ANP-10332P, Revision 0, “AURORA-B: An Evaluation Model for Boiling Water Reactors; Application to Loss of Coolant Accident Scenarios”: U.S. Nuclear Regulatory Commission (NRC) Staff Post-Acceptance Review Feedback and Questions, AREVA’s Response Approach, and Subsequent NRC Staff Audit Comments

A set of 53 questions was prepared by the NRC staff to support an audit of the AURORA-B loss-of-coolant accident (LOCA) methodology. These questions were initially discussed with AREVA during a teleconference on November 1, 2016. During the AURORA-B LOCA audit on May 16-18, 2017, AREVA provided draft responses to the majority of the questions. Based on a brief review during the audit, the NRC staff provided feedback on AREVA’s draft responses. A summary of the technical interactions on each of the 53 issues is captured below.

Assessment of Core Outlet Flow – Middle Ring
Integrated Vapor Mass Flux Between UTP and Upper Plenum

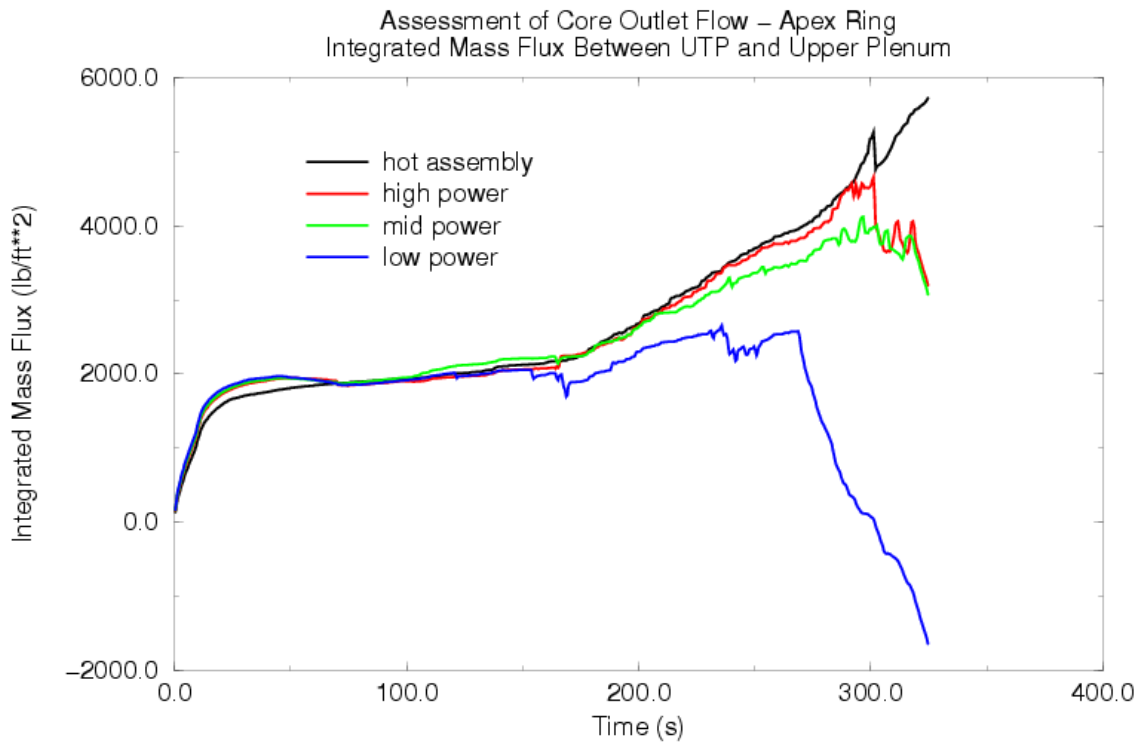
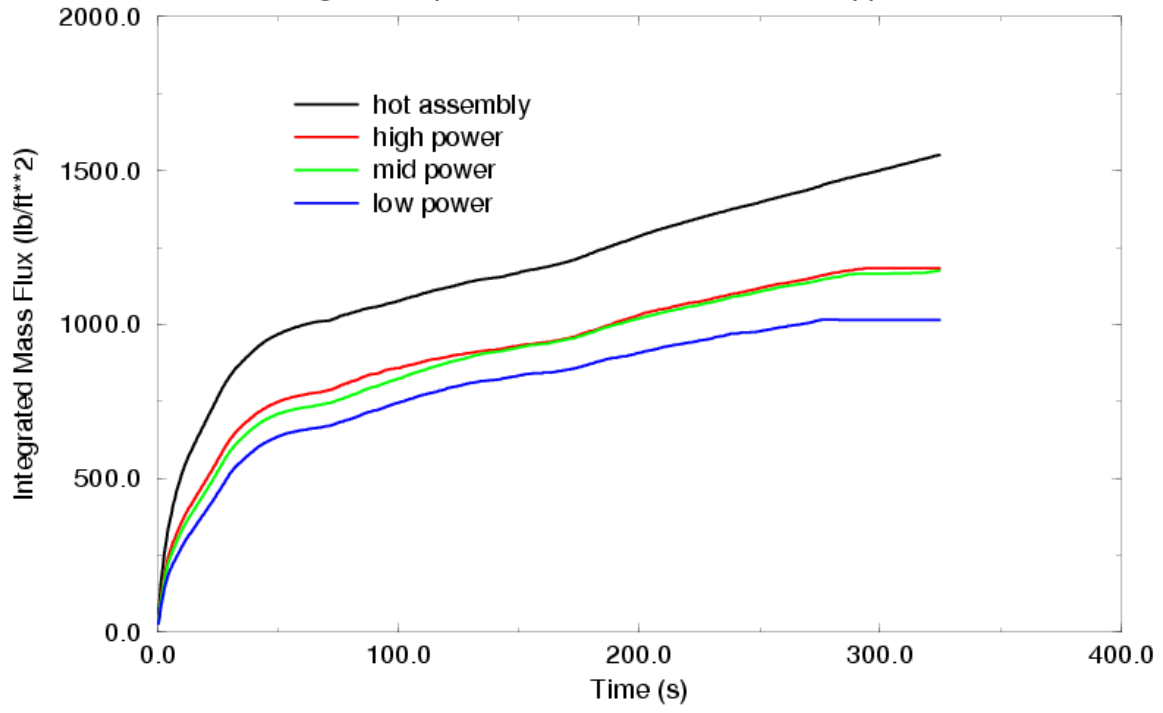
31. NRC staff seeks to understand which channels are in different flow modes for one or more demonstration cases.

Results from BWR/6 large break demonstration case from Section 7.7.6 (1.0 DEG, Pump Suction, SF-LPCS, mid-peaked) are plotted below showing the integrated mass fluxes at the exit of each core channel. [

]. The first three figures show the integrated total, liquid and vapor mass flux for the [
